Construction of a 5 level residential flat building comprising ancillary car parking, landscaping, associated building work and removal of a regulated tree.

81 Anzac Highway, Ashford

211/M029/18

Application No	211/M029/18 Appian 3745
Unique ID/KNET ID	2018/22857/01
Applicant	AWWAD Super Fund Pty Ltd
Proposal	Construction of a 5 level residential flat building comprising ancillary car parking, landscaping, associated building work and removal of a regulated tree.
Subject Land	81 Anzac Highway, Ashford
Zone/Policy Area	Urban Corridor Zone, Boulevard Policy Area 34
Relevant Authority	State Commission Assessment Panel
Lodgement Date	27 November 2018
Council	City of West Torrens
Development Plan	West Torrens Development Plan [Consolidated 12 July 2018]
Type of Development	Merit
Public Notification	Category 2
Representations	Three representations were received, two wish to be heard
Referral Agencies	Commissioner of Highways, Adelaide Airports, Government Architect
Report Author	Karl Woehle
RECOMMENDATION	Development Plan Consent subject to conditions.

Figure 7 - section and render of the Anzac Highway frontage

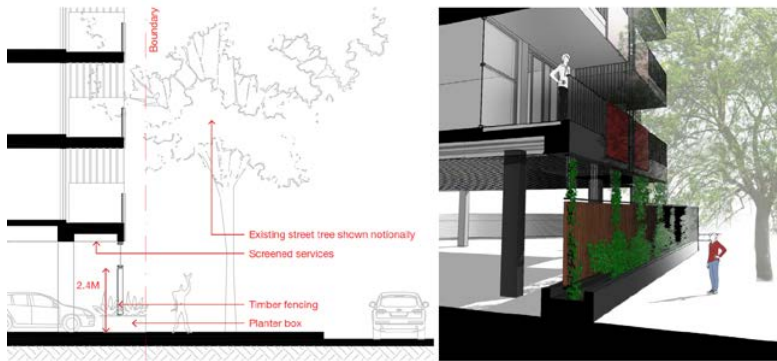
The proposed development is setback 1.5 metres from Anzac Highway at ground which is at odds with 3m front setback envisaged for Anzac Highway. The Government Architect is of the opinion that a greater setback would create for a more meaningful landscaping and enhanced pedestrian experience at ground. The proposed boundary line planter box and timber screening along Anzac Highway provides opportunities to incorporate some landscaping and human scale into the public realm. It is also noted that the residential levels from 1 to 4 are setback 3m from Anzac Highways, reducing the bulk and scale of the development at ground.

Figure 12 – Shadow diagram

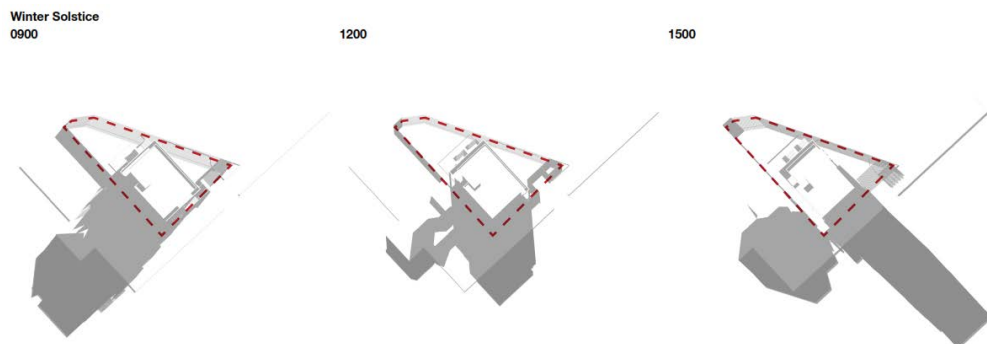
It is considered that the proposed development utilises appropriate design techniques and setbacks to mitigate unreasonable overshadowing of the immediate locality and is generally consistent with the Development Plan.

GROUND FLOOR PLAN

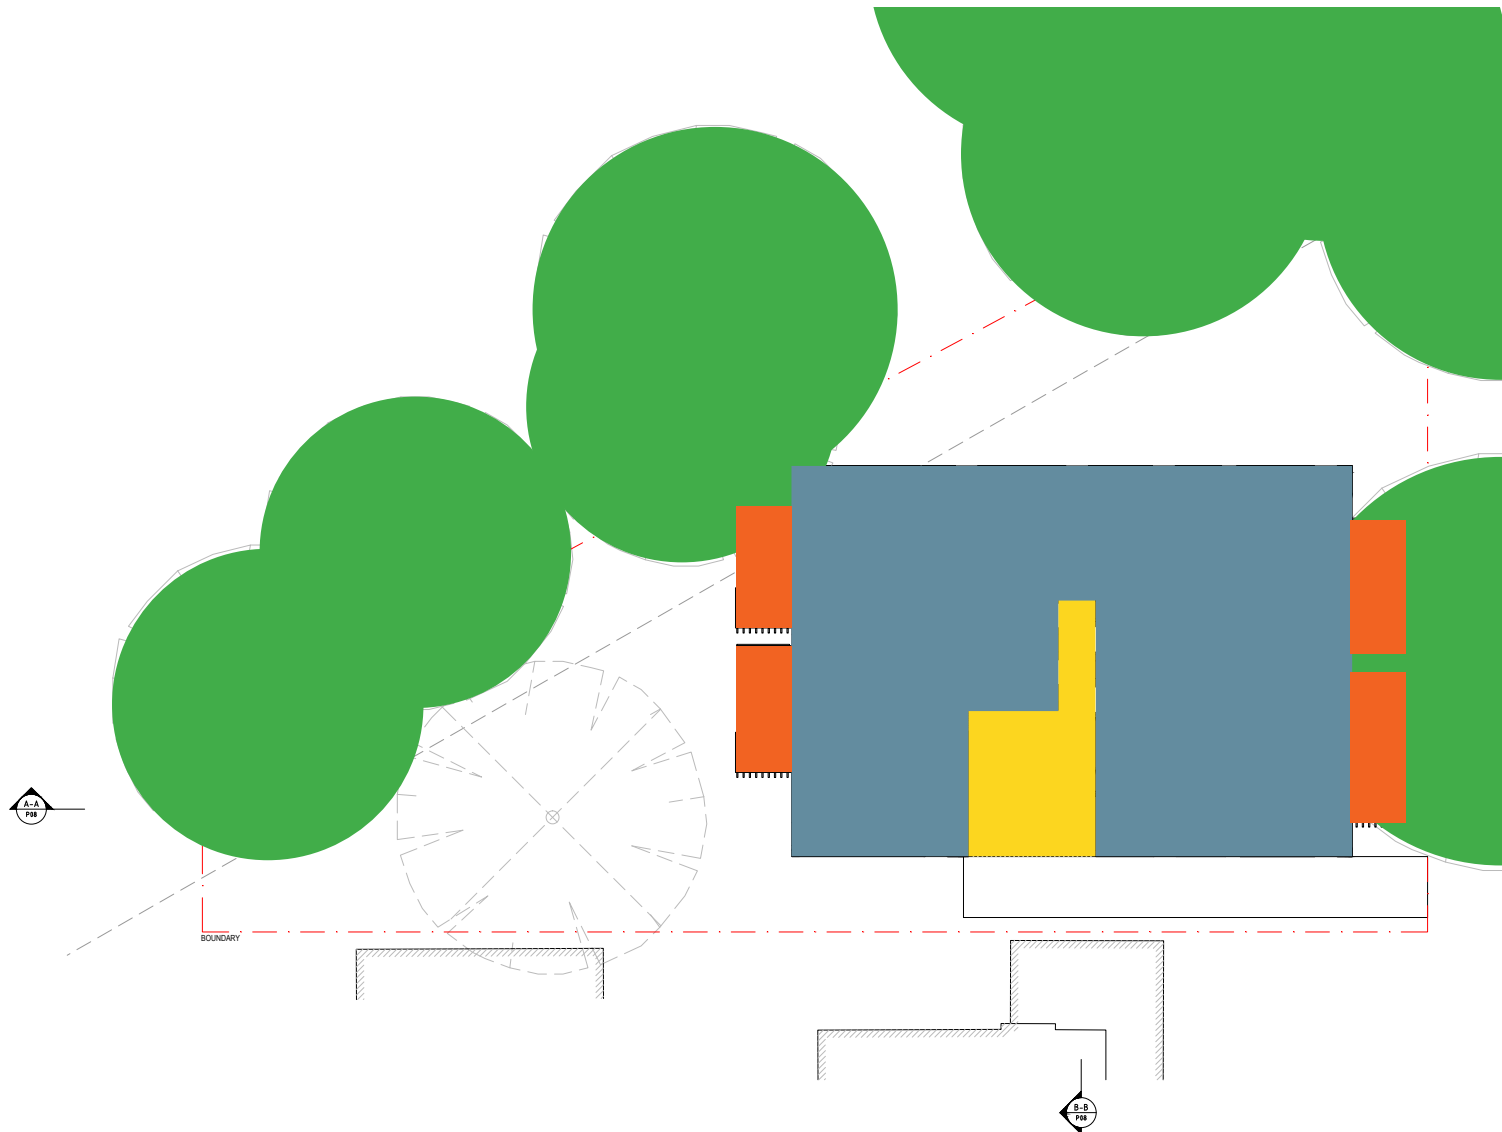
The parking row that faces Anzac Highway has a double column grid within the space length. The two end columns do not match up with the alignment of the two intermediate columns. The proposed location of the two end columns would not meet the door opening requirements in FIGURE 5.2 AS/NZS 2890.1-2004. That is, these columns would obstruct the opening of the front door of the vehicle. The end columns should be adjusted accordingly.

The rear parking row has the columns located approximately 400mm from the start of the space. This would not comply with FIGURE 5.1 of AS/NZS 2890.1-2004, which requires a minimum offset distance of 750mm. The columns should be adjusted accordingly to allow entry into the space to occur.
